HEMI GOLD PROJECT PRELIMINARY DOCUMENTATION

Response to comments

Document	Reviewed	Approved
Site Name: Hemi Gold Project	D Ginger	K Tedesco

Figure 1: Lab bench tests using site water and soil to demonstrate change in V, As and U concentrations

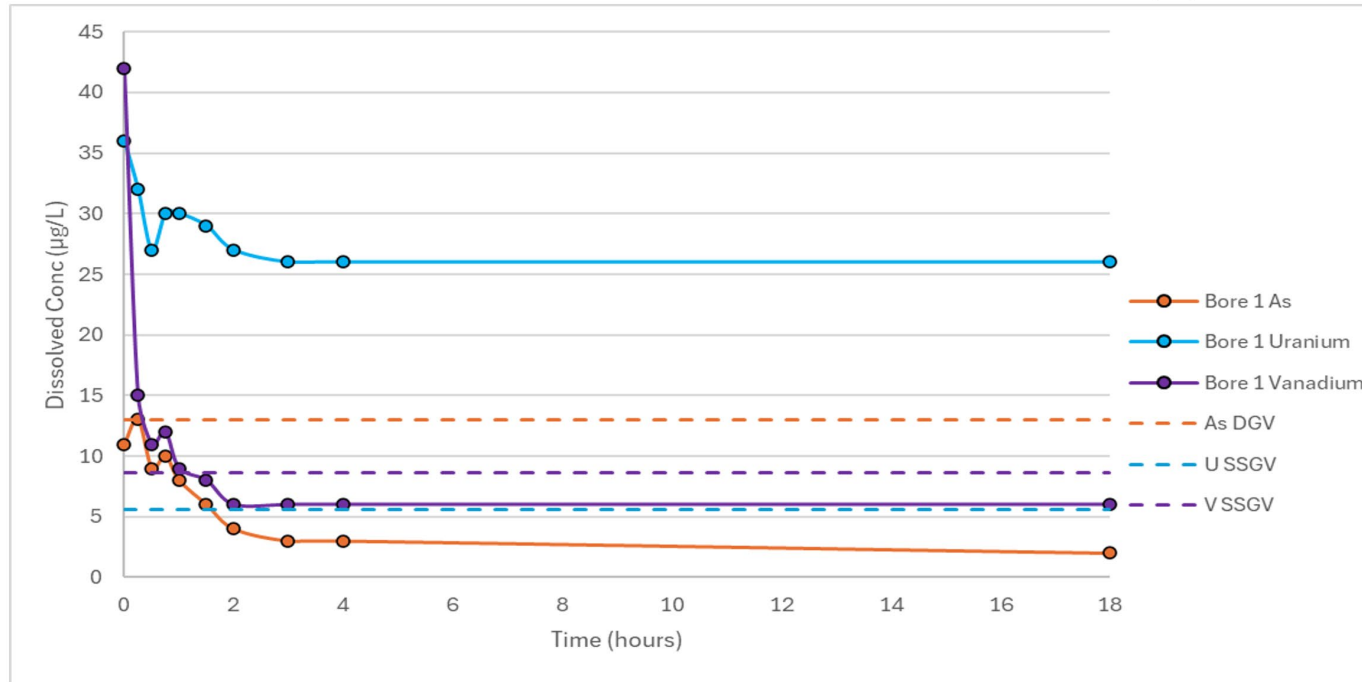
Groundwater Treatment Options	The Tier 3 ERA Ecotox addendum, MBS 2024, Appendix 16 outlines concentrations in the Turner River (post-discharge) would exceed both interim site-specific and regional trigger values for U, V and As. Are there alternative mitigation (treatment) methods available to remove each or any of these elements from surplus water?	<p>Mitigation methods to remove U, V and As from Water to be discharged or reinjected include these alternatives:</p> <ul style="list-style-type: none"> • Soil-based holding ponds and/or iron oxide treatments which effectively reduce vanadium and arsenic concentrations to below trigger levels (uranium remains largely unaffected but is not bioavailable). • Utilising ion exchange as a backup option to remove uranium from a portion of the discharge water. Based on successful ecotoxicity results, this option is not needed as the soil pond-treated water will be suitable for discharge. <p>The current proposal is to utilise soil-based holding ponds as these have been shown during trials to be most effective at removing V and As with most removed within the first two hours of pond residence (Figure 1, taken from MBS 2024a). No other additional and commercially viable options have been identified at this time.</p>	Not required

Date	Topic	Summary of comment	Response	Update to PD
			<p>Post discharge concentrations of arsenic, uranium and vanadium are likely to be heavily influenced by rainfall within the catchment as outlined in Appendix 25 Table 4 (Table 2).</p> <p>Results show dilution and final concentrations are below radiation risk levels. The data also indicates that under the worst case scenario of no dilution that there is no risk of radiation toxicity. Concentrations post-discharge are well below relevant default environmental criteria (i.e. ANZECC Livestock Drinking Water Guidelines) and no impact to MNES from consumption of river water is expected App 15 Table 36 (Table 3).</p>
